5. Tire and Disc Wheel

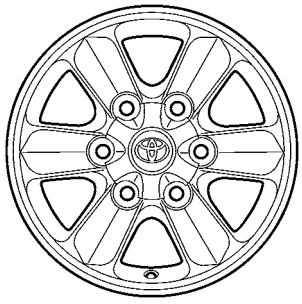
Aluminum alloy wheels are available as an option on all models except Malaysian models and Thai automatic transmission model and some general country models (automatic transmission model for Philippine package).

Tire Size	195R15C
Disc Wheel Size	15 × 6J
Disc Wheel Material	Aluminum
P.C.D.* mm (in.)	139.7 (5.5)
Offset mm (in.)	35 (1.4)
Wheel Design	 04Z1HA07TE
